DATE	REVISION DESCRIPTION
9/28/2016	REVISED PER COUNTY AND VDOT COMMENTS
11/1/2016	REVISED PER COUNTY AND VDOT COMMENTS
1/2/2017	SIGNATURE SETS
6/12/2017	SITE PLAN AMENDMENT #1
9/21/2017	SITE PLAN AMENDMENT #2
10/5/2017	SANITARY SEWER AS-BUILT

LEWISGALE EMERGENCY CENTER
CAVE SPRING DISTRICT - ROANOKE COUNTY - VIRGINIA
Revision
UTILITY PLAN

JOB NO.	38321
SHEET NO.	C4.0

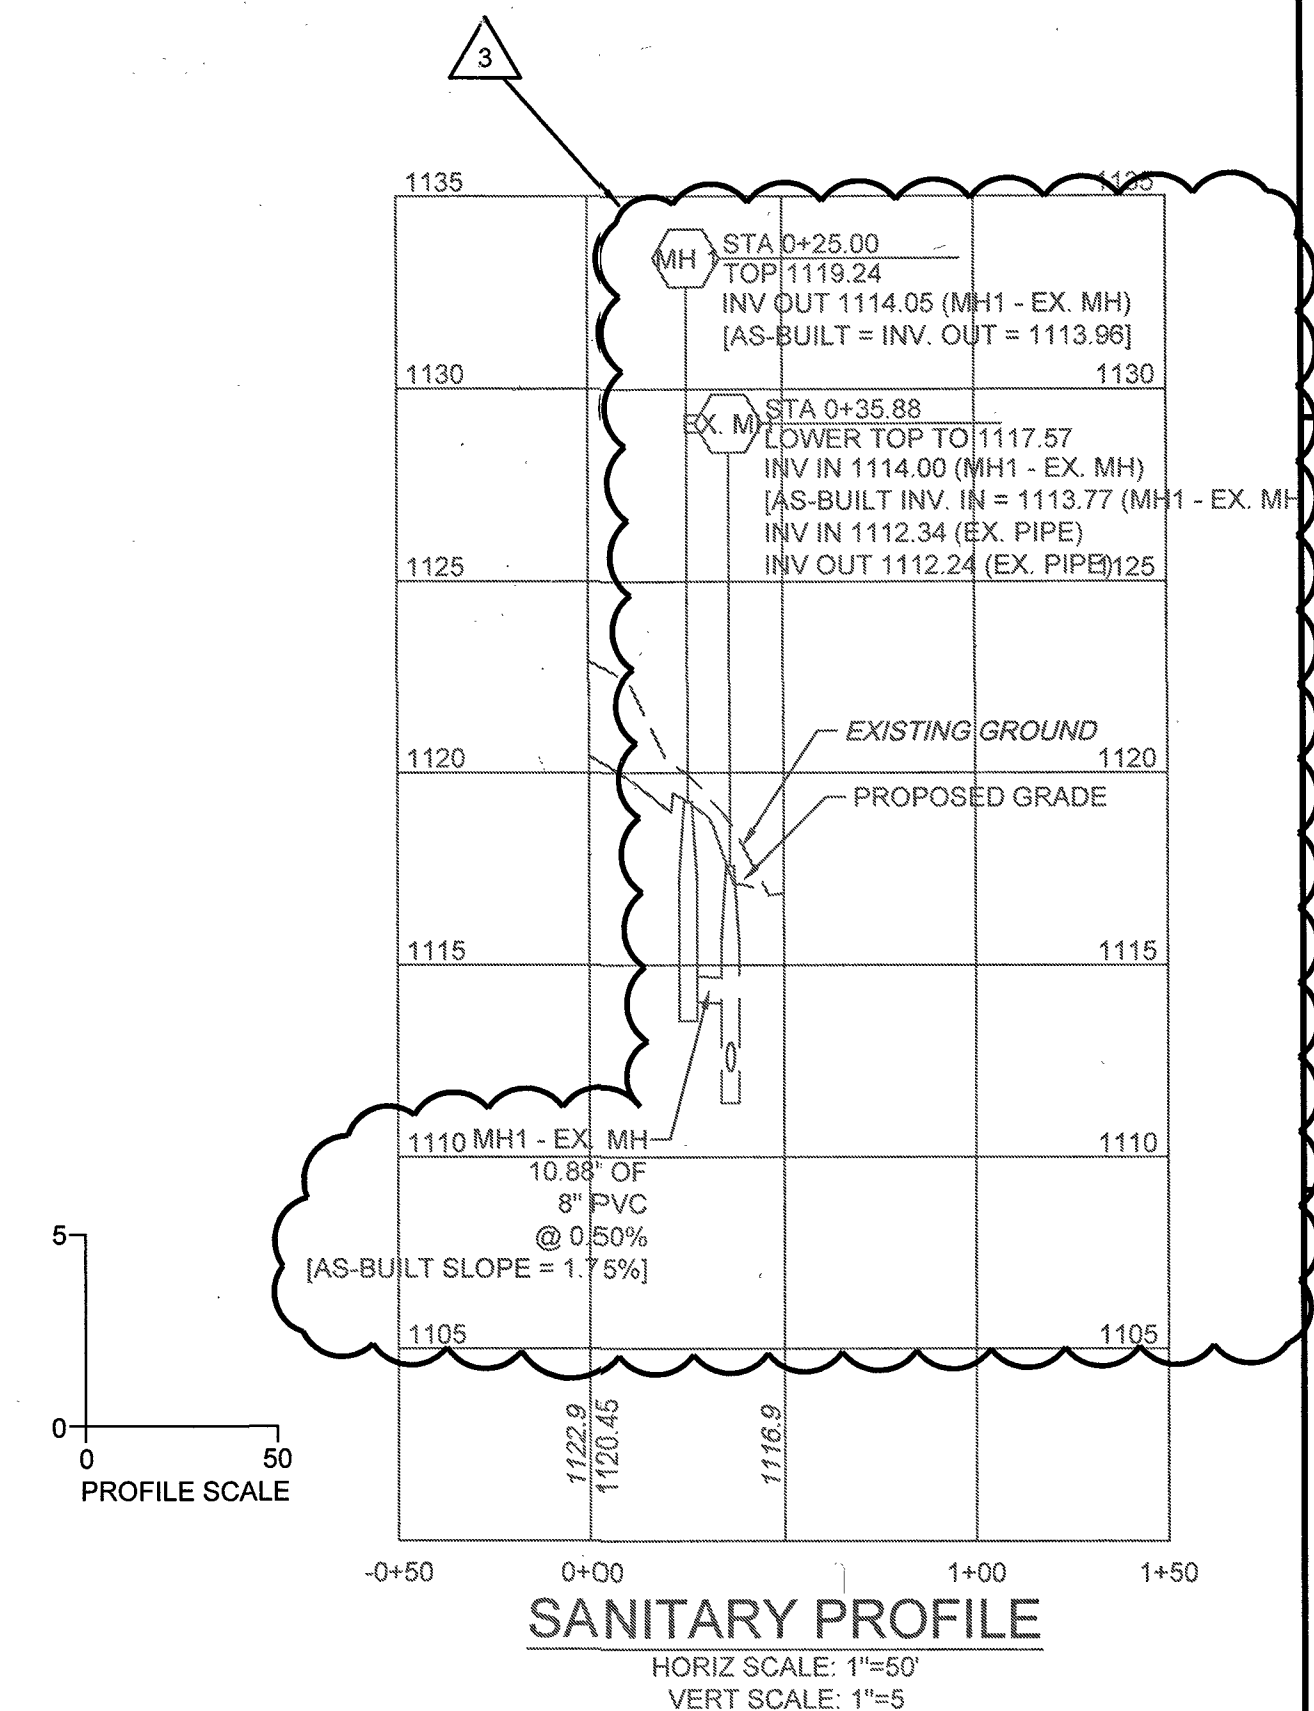
[AS-BUILT: INV. IN = 1113.77
10.88 LF. 8" PUBLIC
PVC S/L @ 0.50%
[AS-BUILT: SLOPE = 1.75%]
MONITORING MANHOLE
INV IN = 1114.05
[AS-BUILT: INV. IN = 1114.08
INV. OUT = 1113.96]

68.49 LF. 6" PRIVATE
PVC S/L @ 4.85%
[AS-BUILT: SLOPE = 4.80%]
